**BEFORE THE PUBLIC UTILITIES COMMISSION  
OF THE STATE OF CALIFORNIA**

R.20-05-003

**CALIFORNIA COMMUNITY CHOICE ASSOCIATION'S  
COMMENTS ON ADMINISTRATIVE LAW JUDGE'S RULING SEEKING  
COMMENTS ON PROPOSED PREFERRED SYSTEM PLAN**

September 27, 2021

## **Table 2. U.S. Drought Monitor Data**

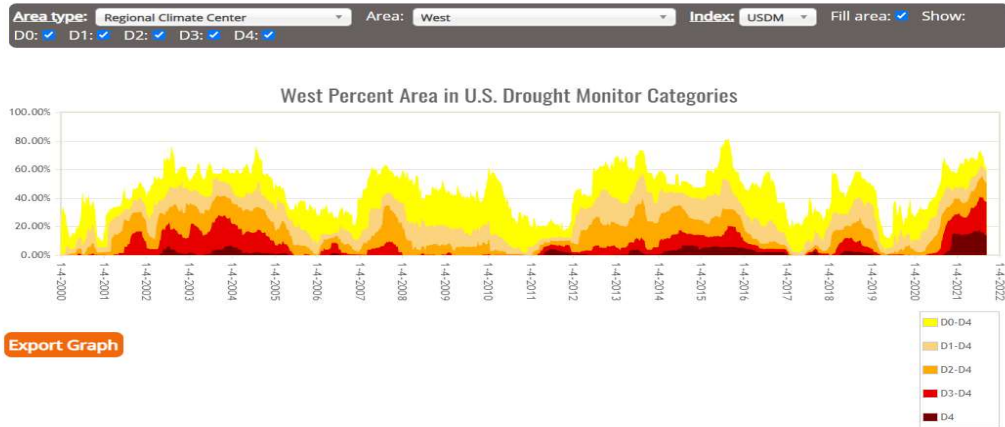
Given predictions of declining hydropower over time, the Commission should be including in its SERVVM analysis at least a derate of hydro capacity to reflect climate change. The SERVVM results predict 25,393 gigawatt hours (GWh) of hydro generation in 2026 and 25,394 GWh in 2030 for the CAISO area — reflecting an average value across the 1998-2017 weather years.<sup>17</sup> According to the California Energy Commission, however, 2020 (drought year) hydro production *for the entire state of California* (i.e., a footprint that includes and is larger than CAISO, which only serves about 80 percent of California load)<sup>18</sup> was only 21,414 GWh, which is substantially lower than the SERVVM values inputted.<sup>19</sup>

Lower hydro production is likely to continue given the prolonged drought, and thus the CPUC should adjust its historical hydro data going forward. Table 1 below shows drought indices in the west, with darker colors indicating more severe droughts. Since 2021, the dark brown colors indicate that severe drought has increased, in both persistence and magnitude, beyond any level seen since 2000.<sup>20</sup>
